ADDENDUM NUMBER 2 ON INVITATION TO BID ITB19KO-130

TITLE: Sid Martin Biotech Reroof

Addendum #2

1. These five (5) typed pages.
2. Drawing sheets A7.1 & A7.2, revised 6-4-2019.

3 LADDER OVER PARAPET DETAIL
SCALE: 3/8" = 1'-0"

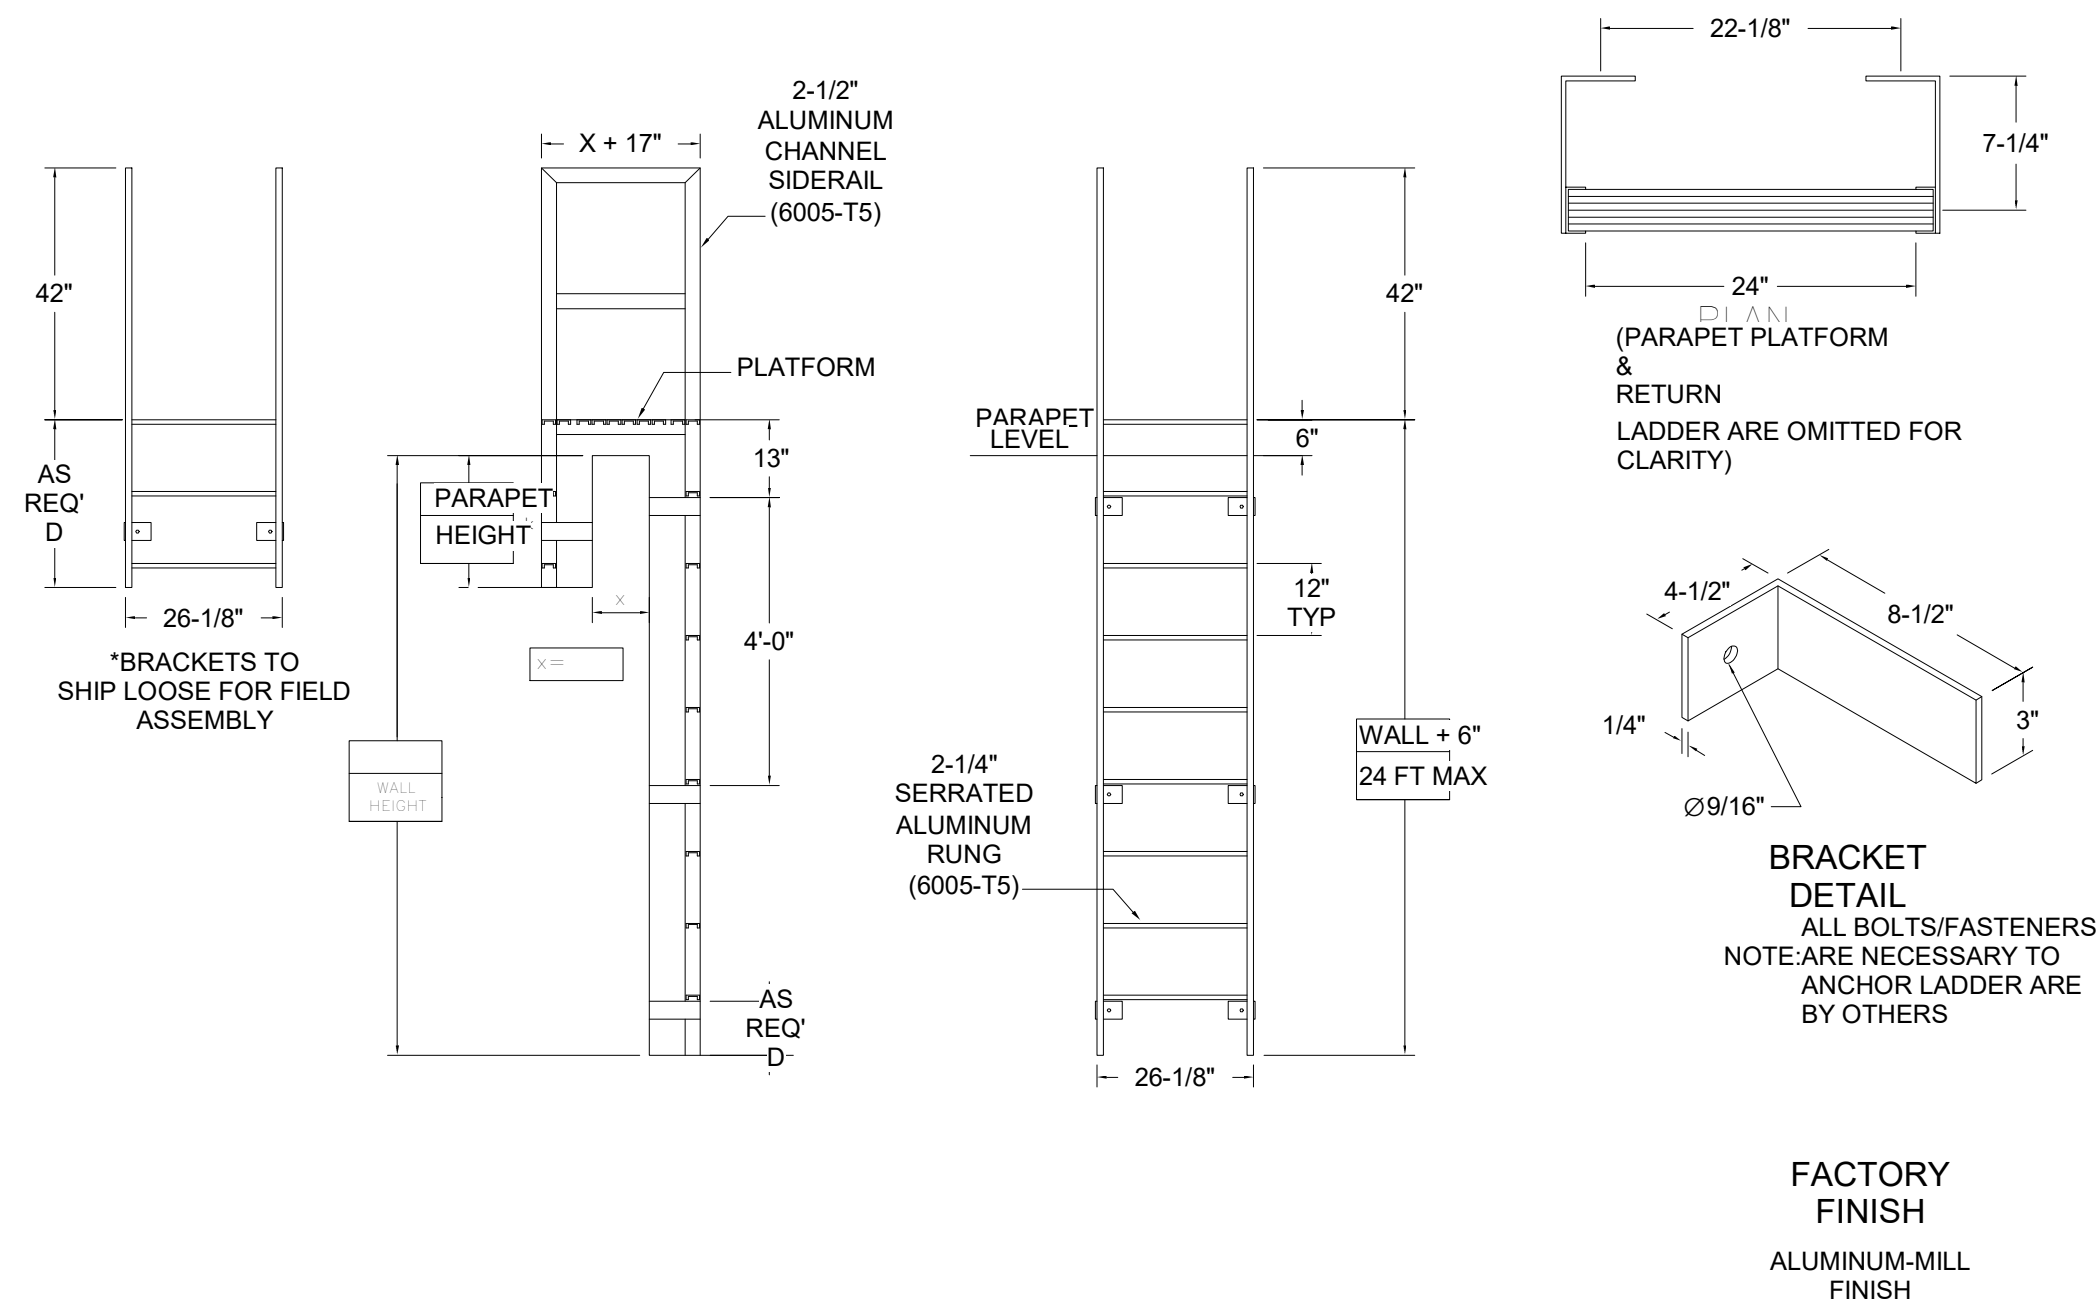
- A6. When submitting the cost for this alternate, also provide any additional contract time that may be required for completion.
- Q7. Can drawings be provided of the wall section details at the proposed ladder locations?

- A7. Yes. See detail 2/A7.2 on attached drawing A7.2, revised 6-4-2019.
- Q8. Can drawings be provided of the existing decking orientation?
- A8. Decking orientation is unknown.
